STATE OF NORTH CAROLINA
DEPARTMENT OF TRANSPORTATION

Subject: Modification Request for the Individual Section 404 Permit, Individual Water Quality Certification, and Tar-Pamilico Buffer Authorization for the Rocky Mount Northern Connector, from SR 1604 (Hunter Hill Road) to US 301, Nash County, TIP No. R-2823, Debit \$570 from WBS 34509.1.1.

In an application dated December 17, 2008, the North Carolina Department of Transportation (NCDOT) submitted an Individual Permit application for the Subject project. This application requested authorization for impacts to jurisdictional features based upon a final design prior to an additional public meeting presenting the final design, held on October 28, 2008. Based upon comments from the meeting and subsequent inquiries from the public concerning the traffic flow from Station -L- 27+45 to Station 65+55, the roadway was re-designed to include directional crossovers and four bulb U-turns to provide additional left-turn traffic flow along Woodruff Road. The redesign will result in unavoidable impacts to Waters of the U.S. Revised permit drawings, buffer drawings and roadway plans are included with this modification request.

REVISED 06/11/09
PERMIT DRAWING
SHEET 10 OF 68

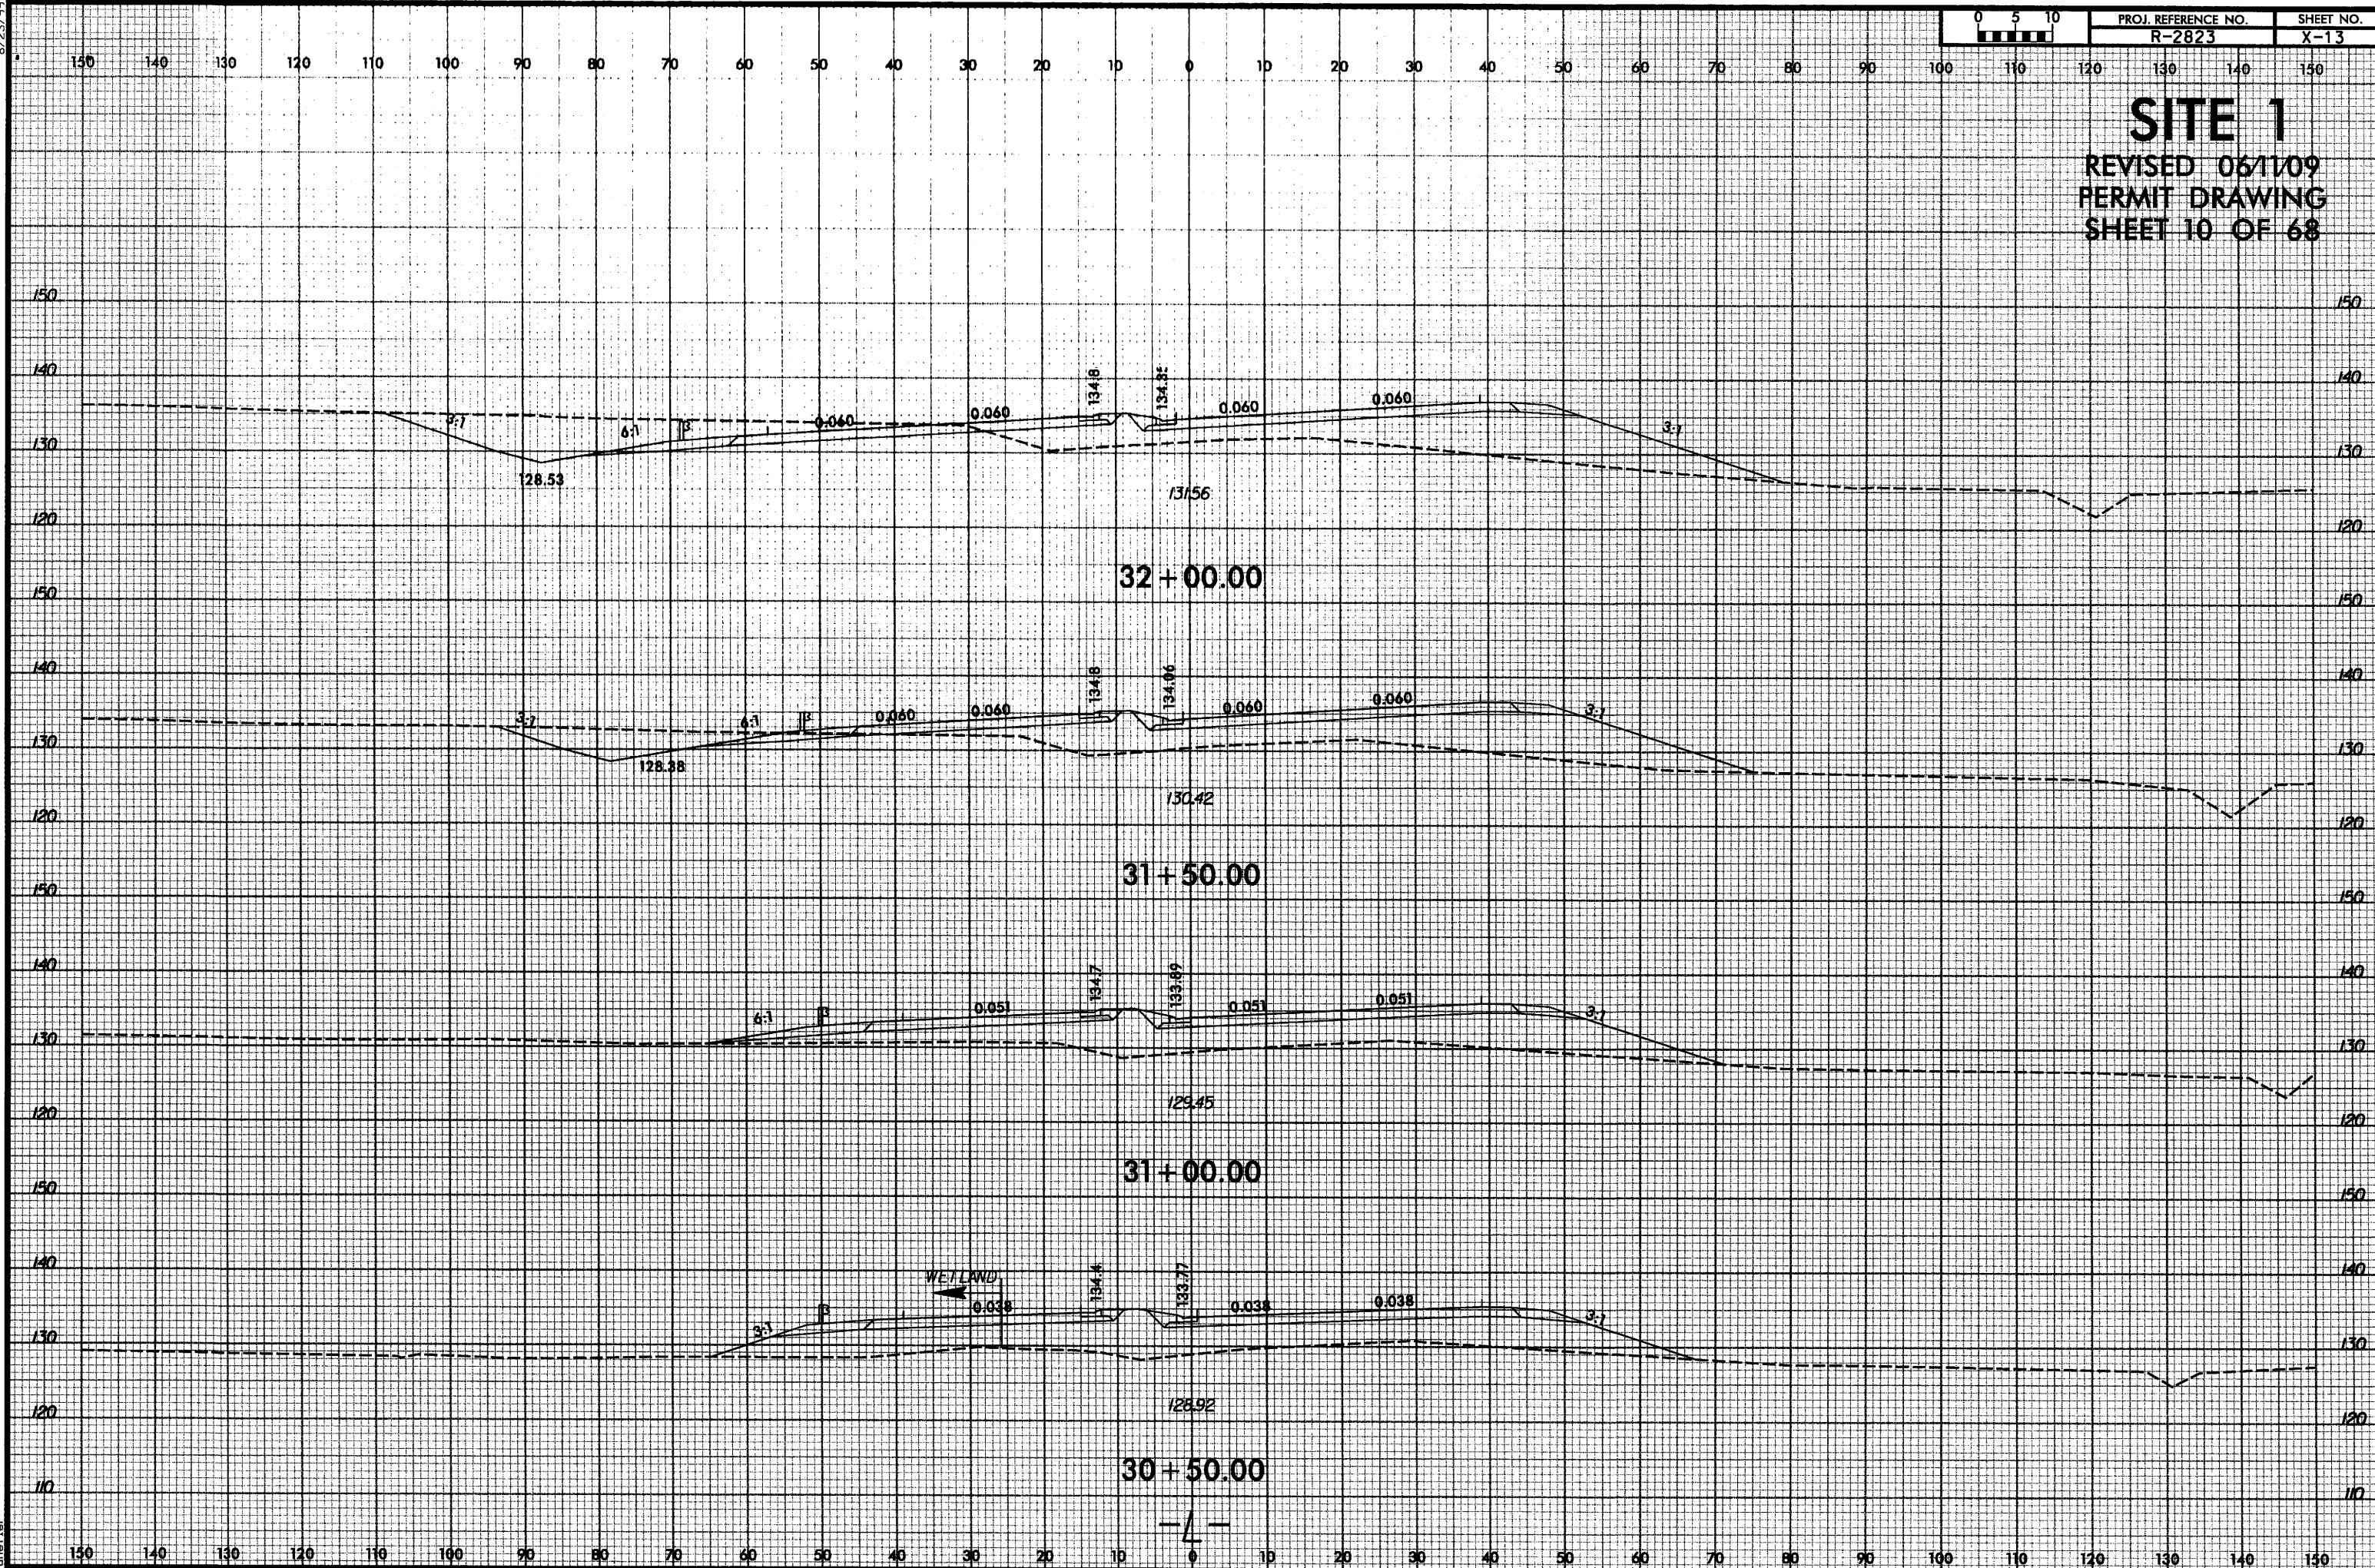
Revised cross section permit sheets 9 and 10 of 68 (buffer sheets 9 and 10 of 56) are enclosed.

PROJECT REFERENCE NO.	SHEET NO.
R-2823	7
ROADWAY DESIGN ENGINEER	HYDRAULICS ENGINEER
REVISED 06/10/99 PERMIT DRAWING SHEET 14 OF 68

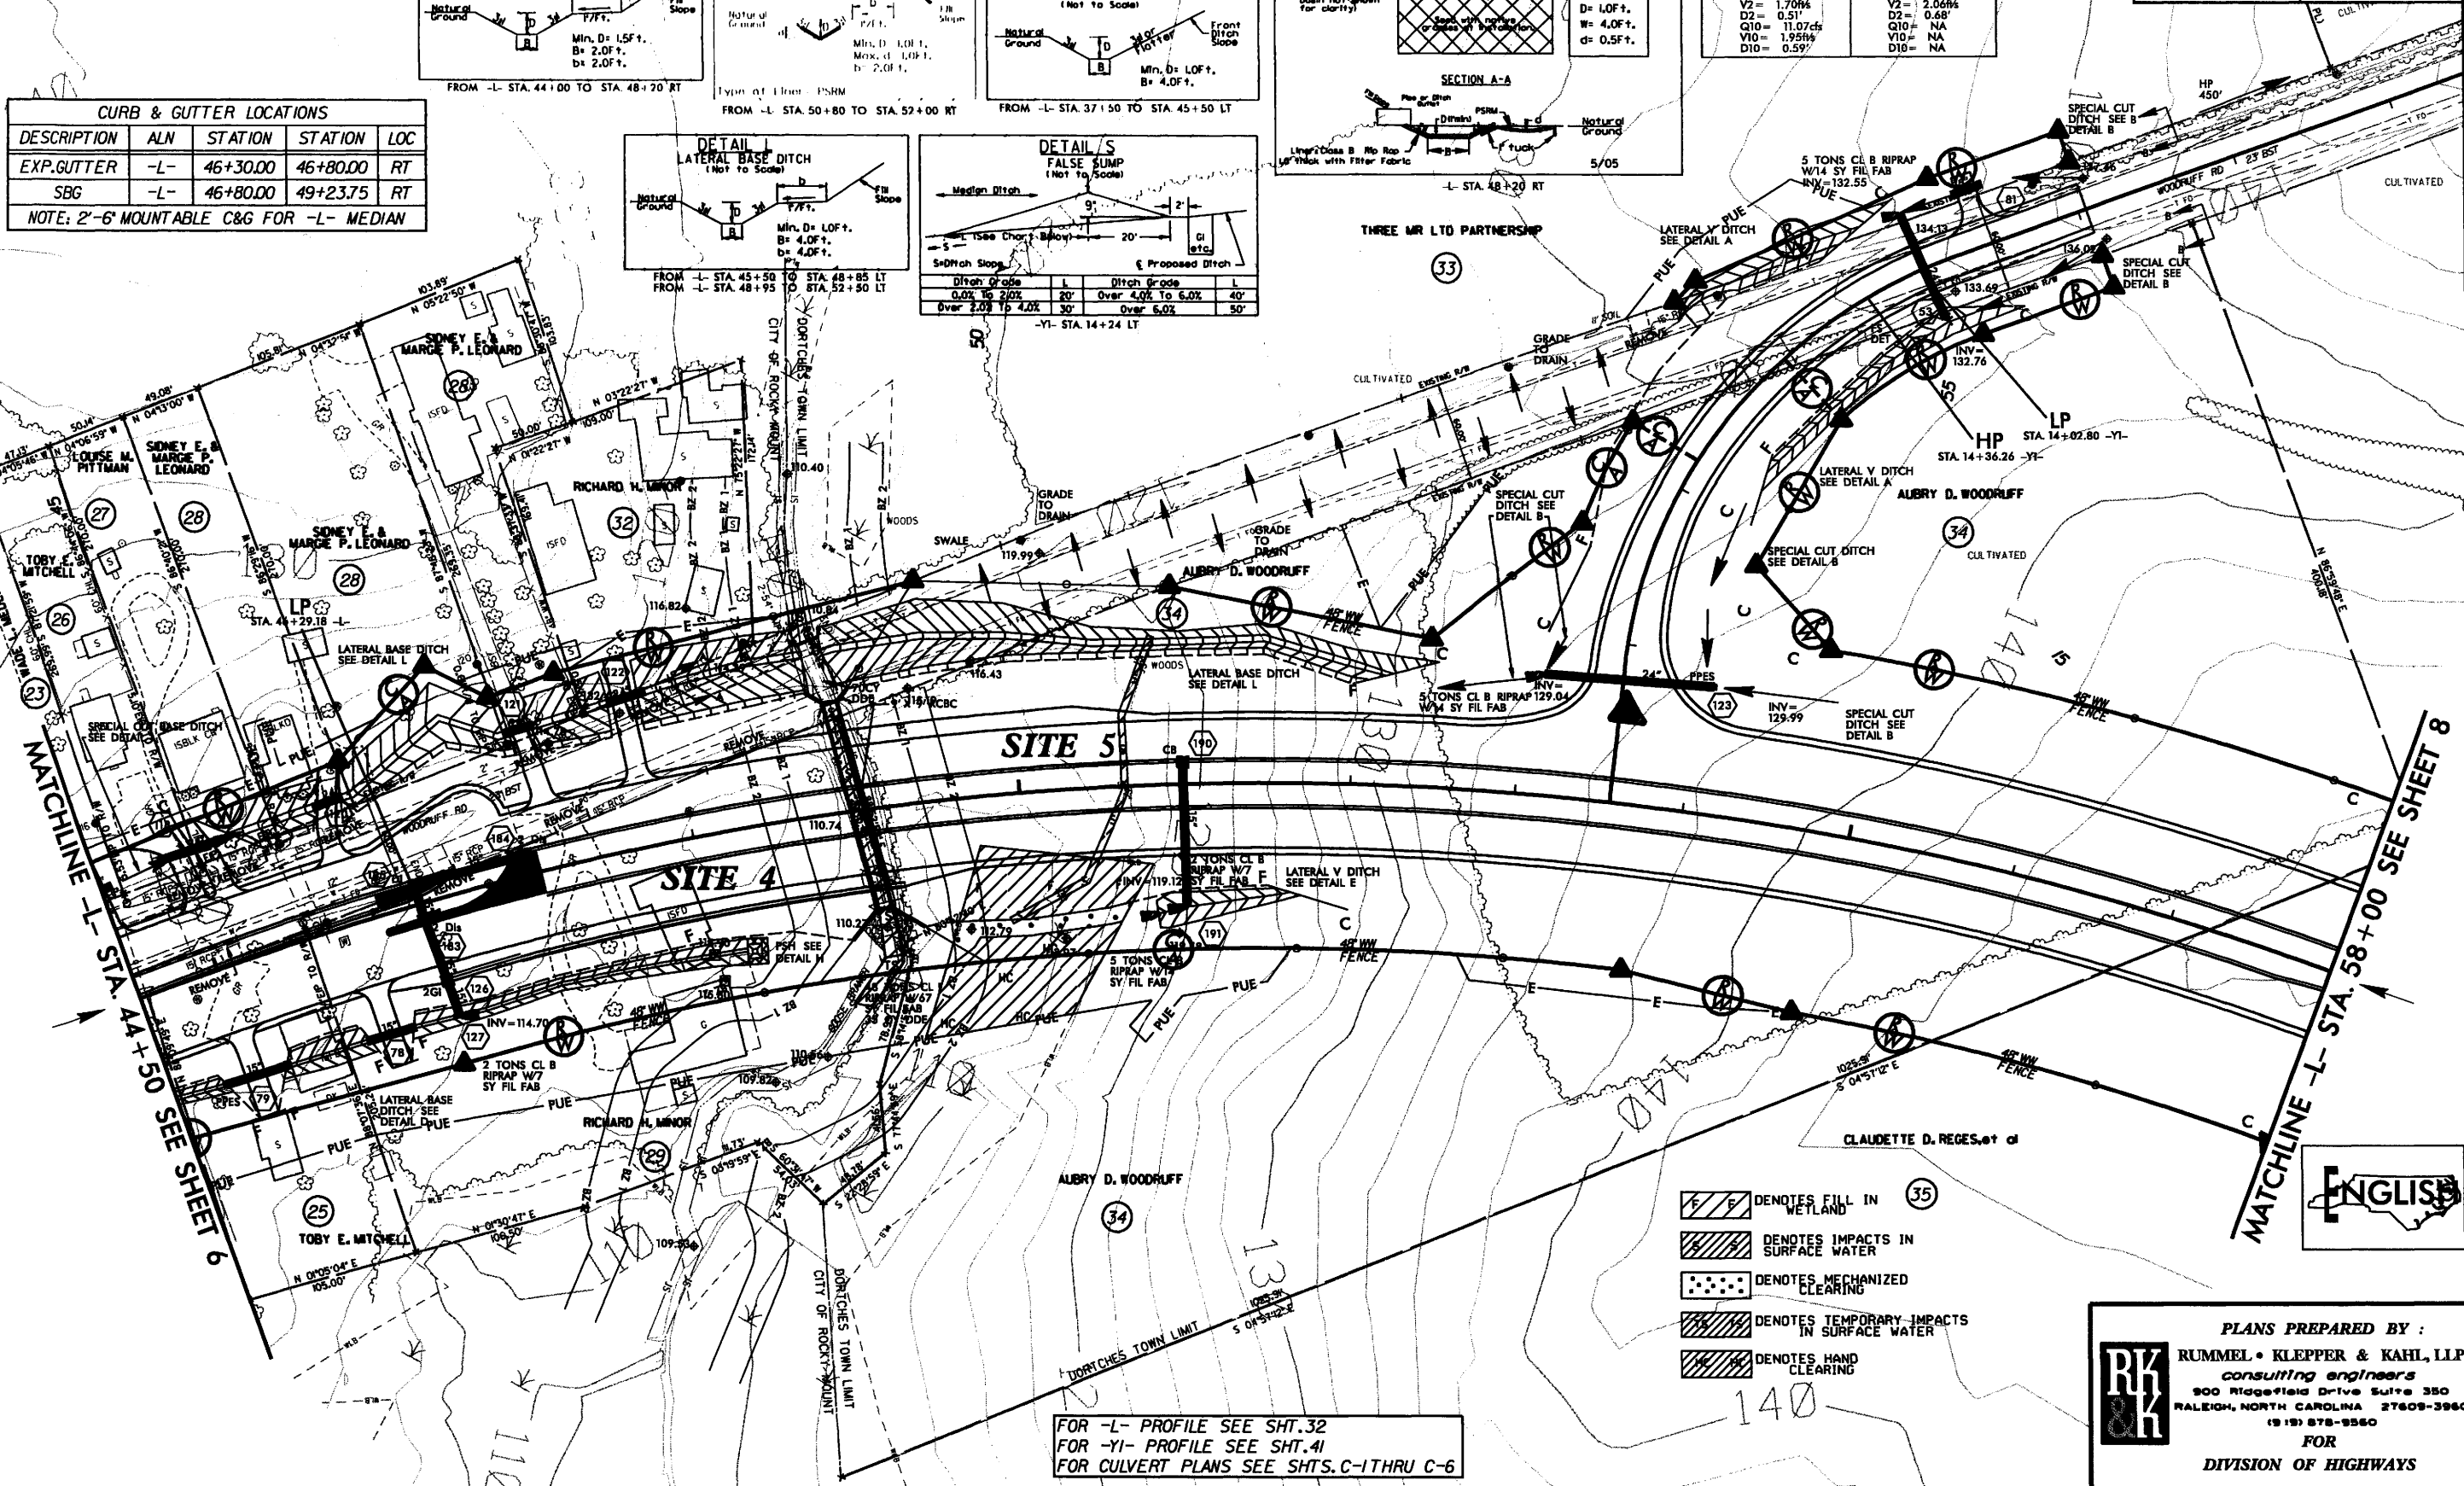
The revised drawings (Permit Sheets 14 and 15 of 68 and Buffer Sheets 15 and 16 of 56) indicate that impacts at Site 4 will change due to aerial utility lines. The sheets have also been revised due to a new bulb which does not have an impact on the environmental features. A summary of the original and revised impacts is provided in the following table.

The revised drawings (Permit Sheets 14 and 15 of 68 and Buffer Sheets 15 and 16 of 56) indicate that impacts at Site 5 will change due to aerial utility lines. The sheets have also been revised due to a new bulb which does not have an impact on the environmental features. A summary of the original and revised impacts at Site 5 is provided in the following table.

Impact Description	Dec. 17, 2008 Impact	Revised Impact	Impact Change
Perm. Surface Water Impacts	0.04 Ac (158 LF)	0.04 Ac (158 LF)	None
Temp. Surface Water Impacts	0.01 Ac (54 LF)	0.01 Ac (54 LF)	None
Wetlands in Buffer Zone 1	41 sq ft	168 sq ft	+127 sq ft
Wetlands in Buffer Zone 2	574 sq ft	1,712 sq ft	+1,138 sq ft
Mitigable Buffer Zone 1	10,527 sq ft	11,823 sq ft	+1,296 sq ft
Mitigable Buffer Zone 2	6,437 sq ft	7,647 sq ft	+1,210 sq ft

Impact Description	Dec. 17, 2008 Impact	Revised Impact	Impact Change
Fill in Wetlands	0.08 Ac	0.08 Ac	None
Mech. Clearing in Wetlands	0.03 Ac	0.03 Ac	None
Hand Clearing in Wetlands	0	0.11 Ac	+0.11 Ac
Perm. Surface Water Impacts	0.02 Ac (210 LF)	0.02 Ac (210 LF)	None
